NS-NRC-85-3025

Subject: BART-WREFLOOD Input Revision

BART Vin ISSUE SUMMARY

FIGURE 1
 WREFLOOD OUTPUT (SOLID LINE) COMPARED WITH
 FLOODING RATE INPUT TO BART

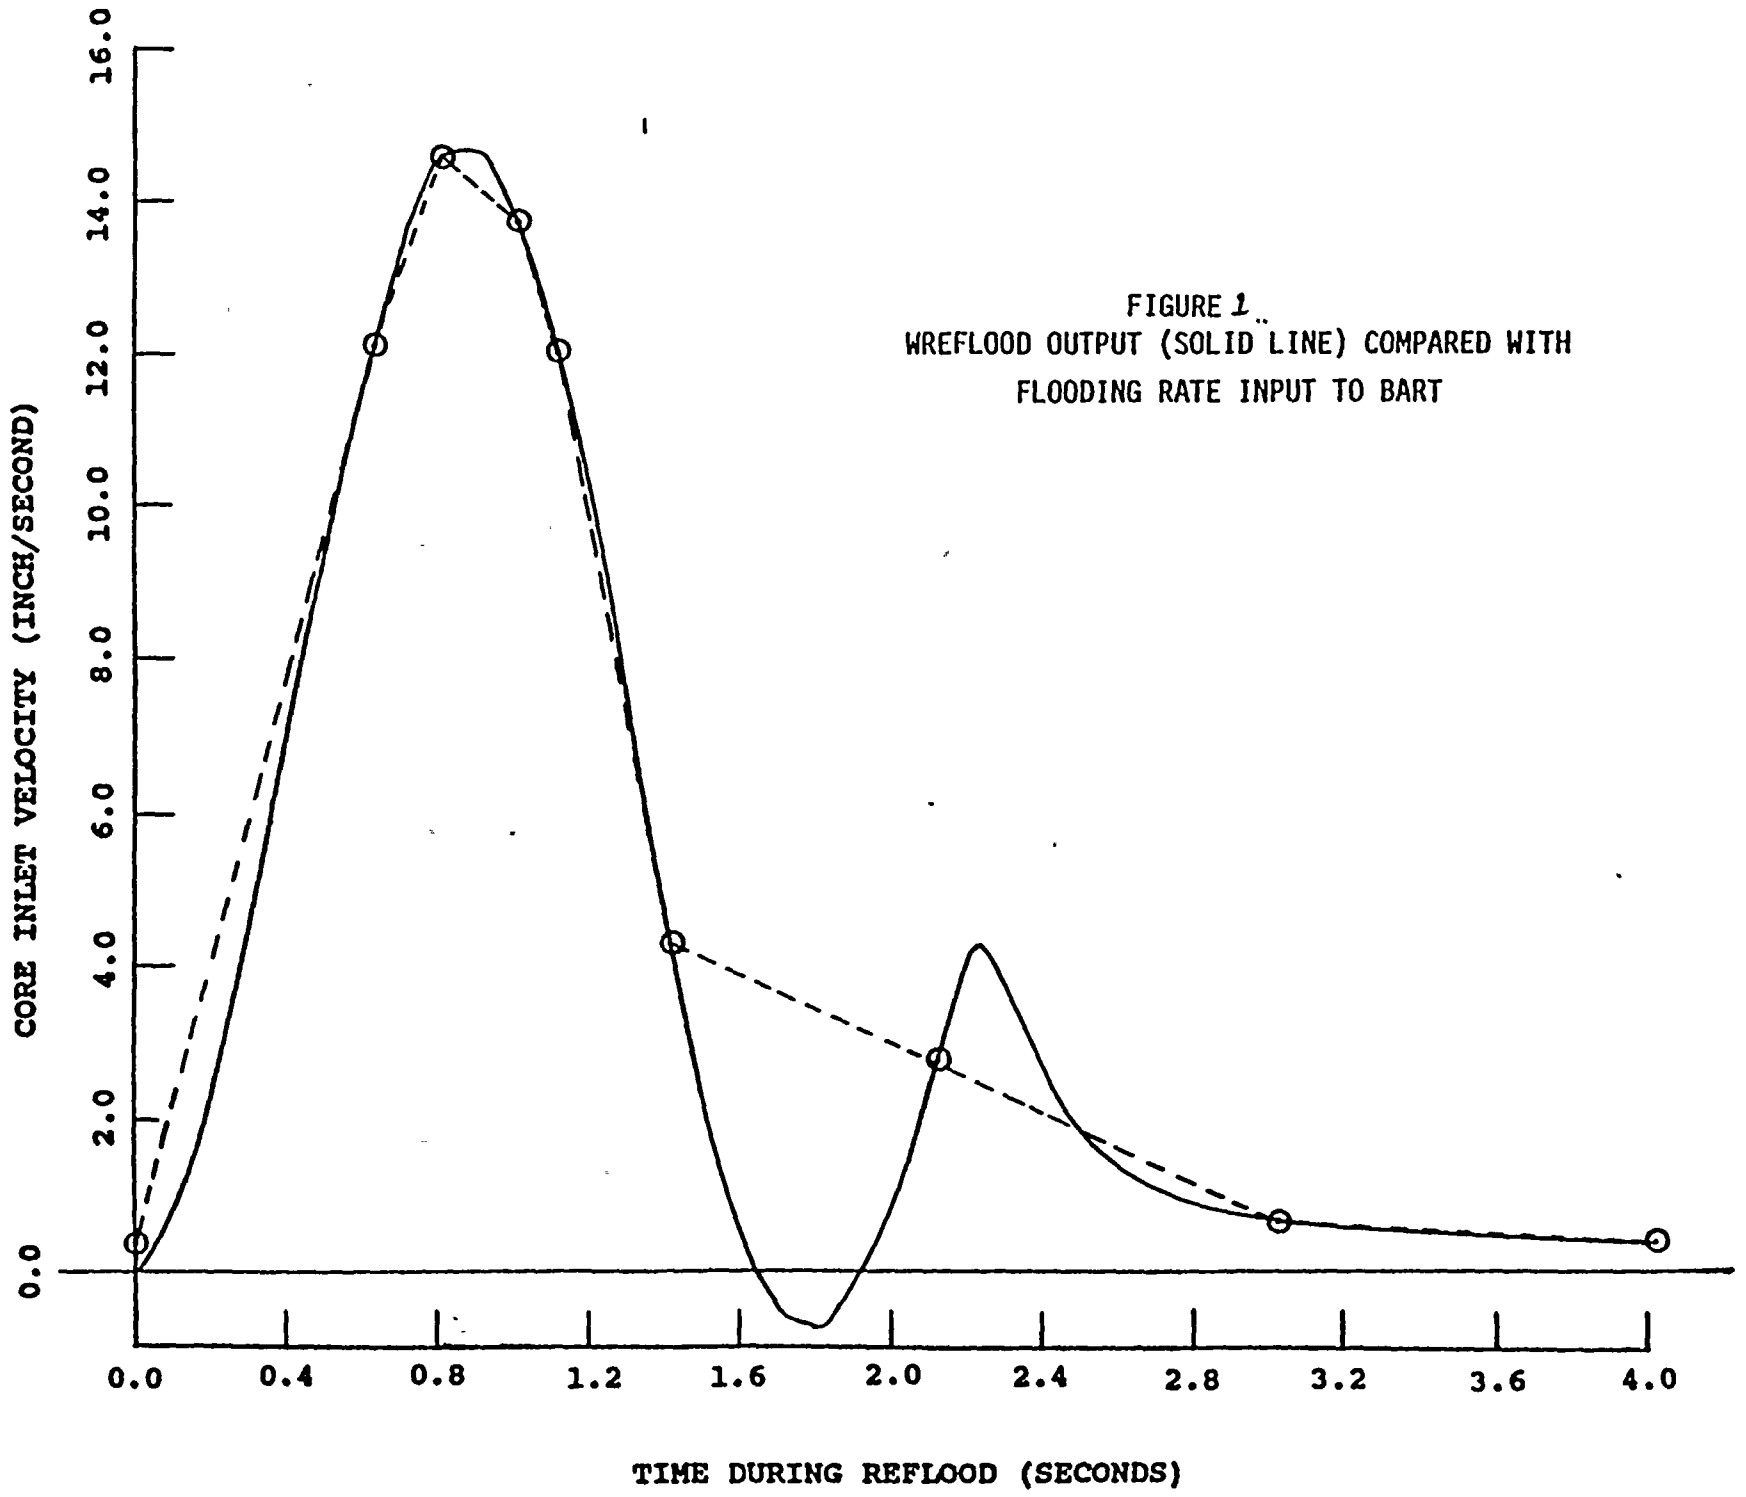
A representative example of WREFLOOD output and BART input is presented in figure 1. It can be seen that the area under the BART input Vin curve is greater than under the WREFLOOD output Vin curve. The BART points are the WREFLOOD values normally available to the analyst.

As a result the integrated value of water in the core may be higher in BART than in the WREFLOOD code. This higher water level provides an earlier onset of entrainment which results in an earlier initiation of steam cooling in the upper regions of the core. This earlier initiation of steam cooling gives a lower calculated PCT than would be calculated if the integrated value of the Vin curve from WREFLOOD had been matched exactly.

A data transfer procedure, utilizing the available WREFLOOD Vin output, has been developed and implemented that results in good agreement between the WREFLOOD calculated value of the integrated flooding rate and the BART calculated value of the integrated flooding rate. This procedure also cautions the analysis reviewer to verify the similarity of the integrated Vin curves between the two codes and provides a standard method for comparing the two curves.
